2006 HBMP Comprehensive Summary Report

Appendix B – Scientific Review Panel Comments

Appendix B – Comments as Received from Scientific Review Panel Members

Figure 10.1
Conceptual Model of the Peace River Estuarine System

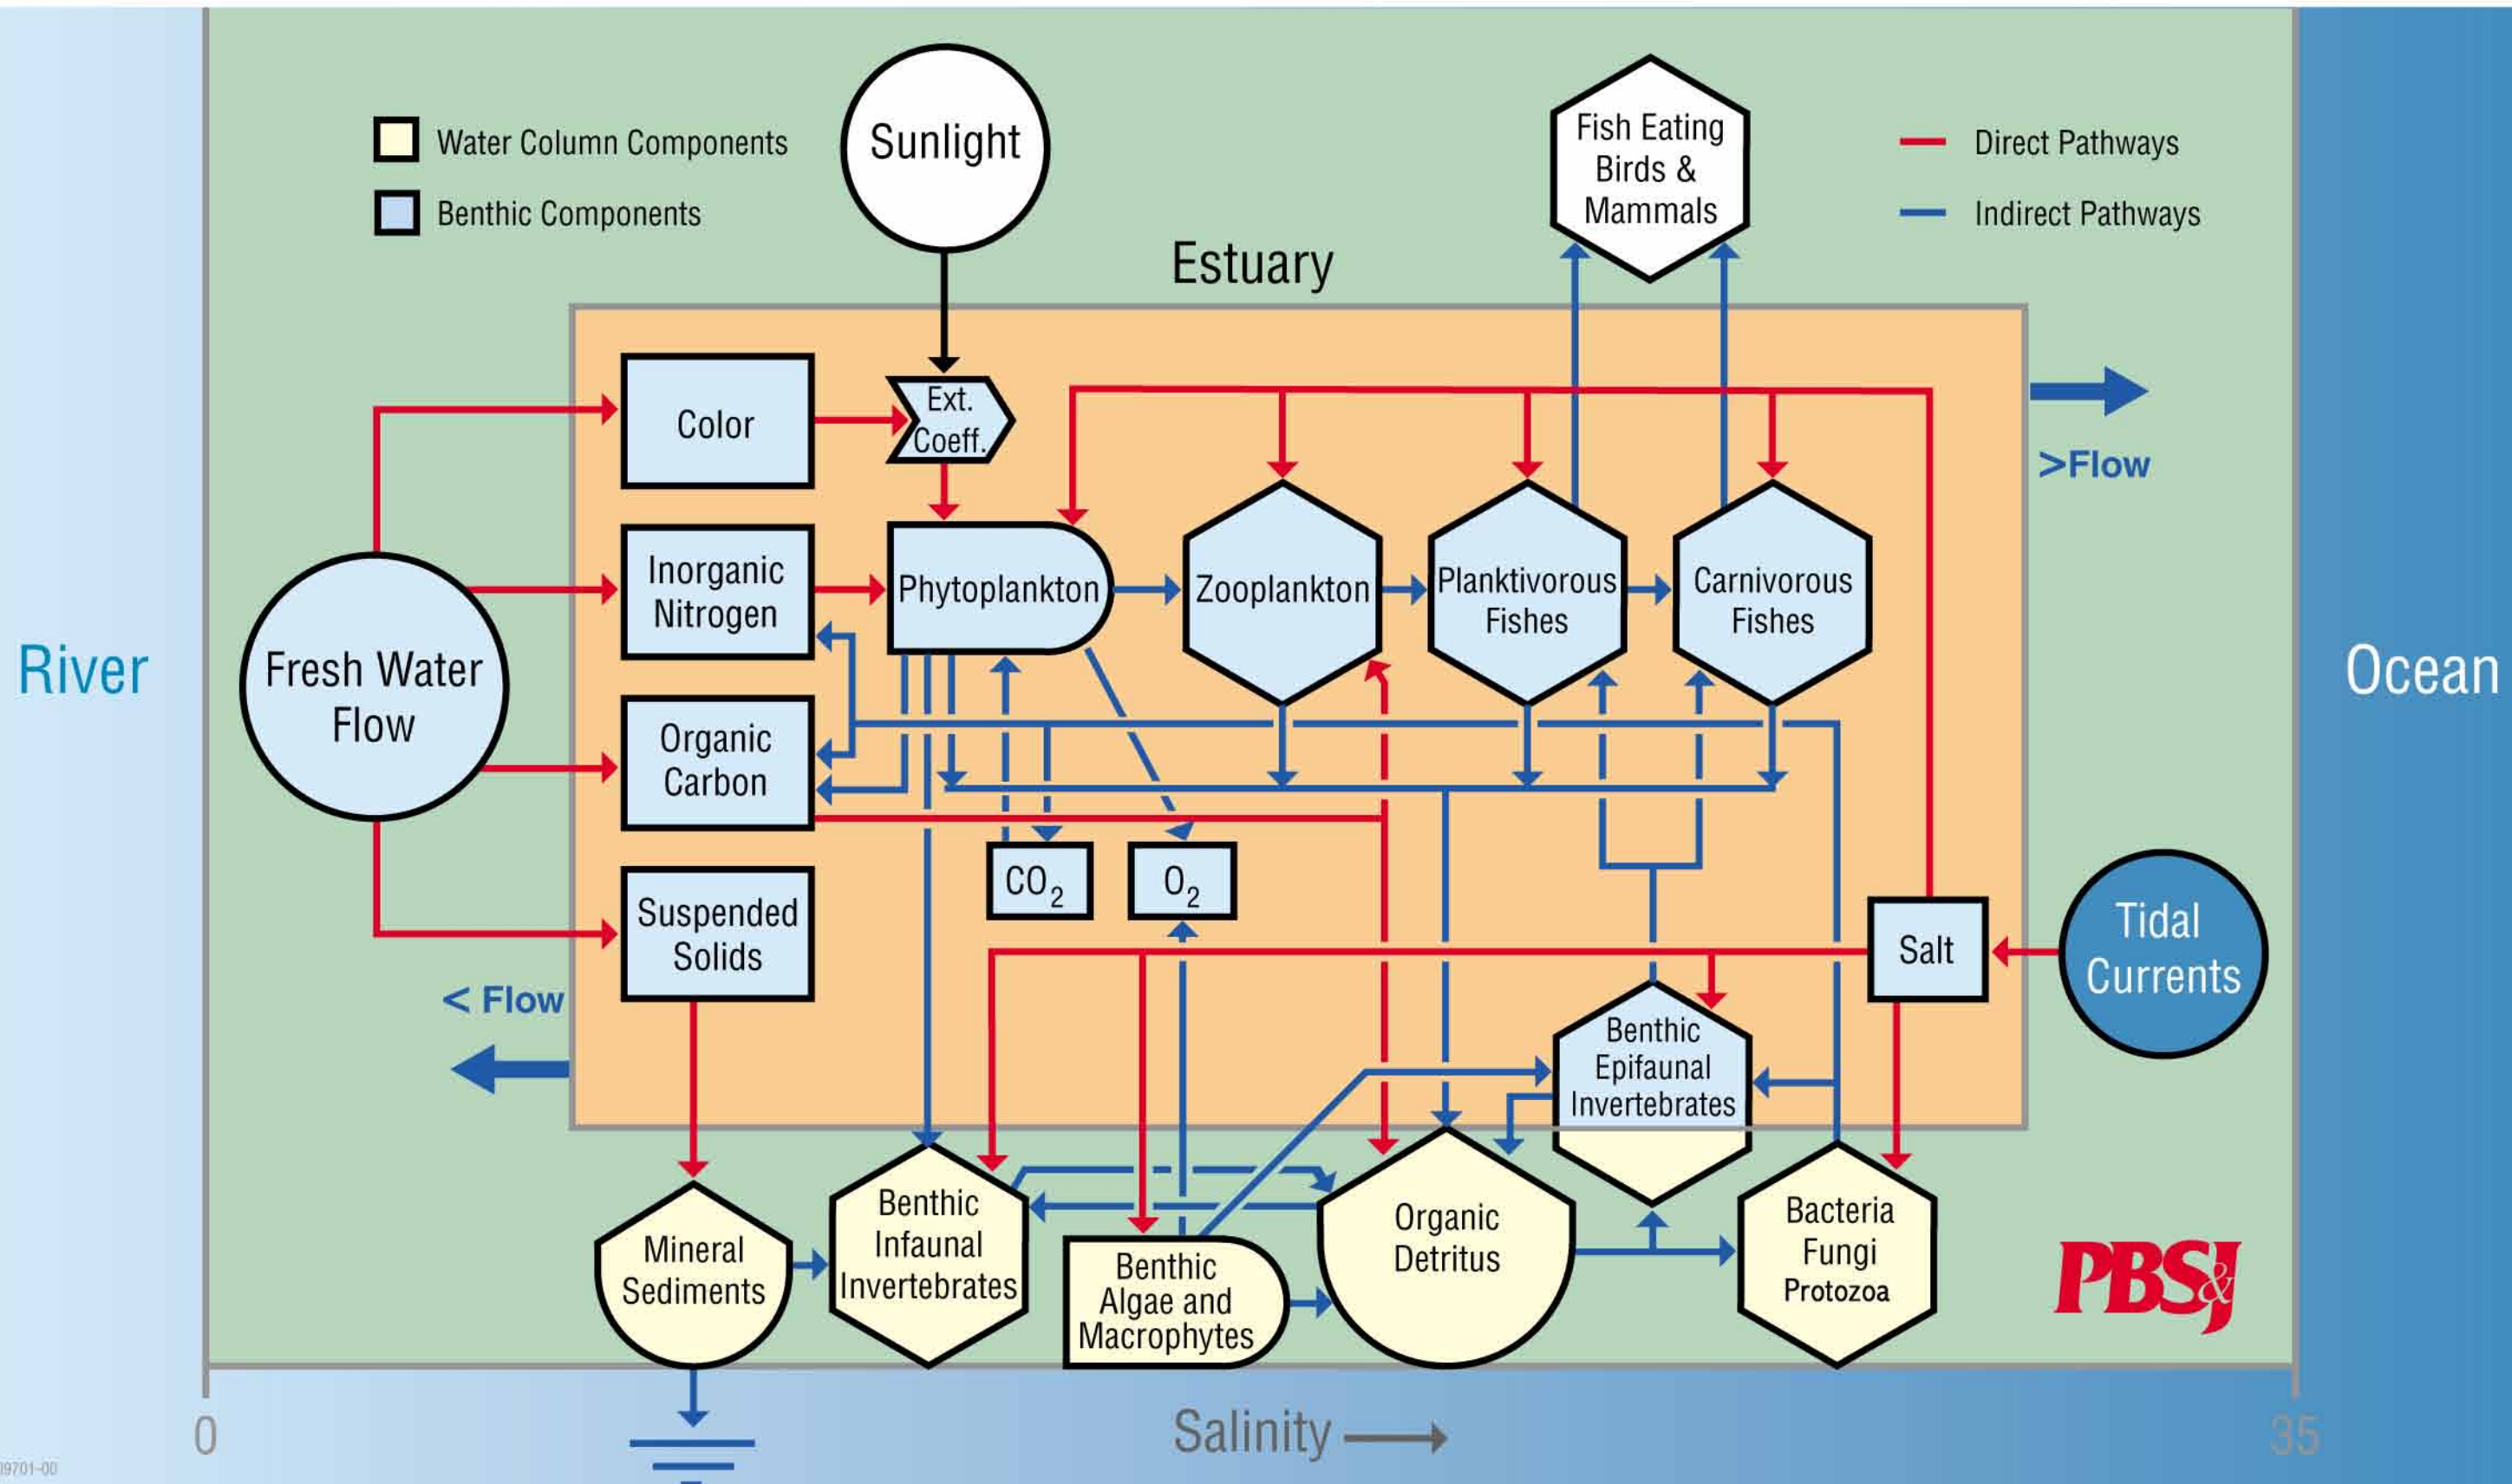
Indicators of Environmental Change: Figure 10.1 is a critical element for identification of key indicators of environmental change and should be the basis used to identify critical indicators. This figure is a major step forward in this process and should be presented early in the Report Summary in my opinion. Because this figure and the information is so important, it is critical that the direct and indirect linkages as well as elements of this figure be discussed/reviewed in detail. I feel that an important missing element of the conceptual diagram is the connection between flow (volume and rate) and current and historical land uses. At some point a table/matrix summarizing the indicators by category (critical, desirable, potential) that have been or are currently measured and the indicator criteria they represent or address (e.g., spatially responsive, unambiguously interpretable, etc.) probably should be developed. I am also concerned that food web linkages are shown as indirect linkages. This figure needs considerable discussion at the next meeting of the HBMP Scientific Review Panel.

10-4	Fig 10-1	The conceptual diagram needs to show the linkages between volume and rate and land use/anthropogenic activities. It also does not show any linkages with emergent vegetation. Is this because there never was one and the historical monitoring of this was unnecessary or because the facility related changes in hydrology/flow are not of a magnitude that are likely to causes changes. If this diagram had been developed at the start of the study maybe vegetation never would have made the indicator list.
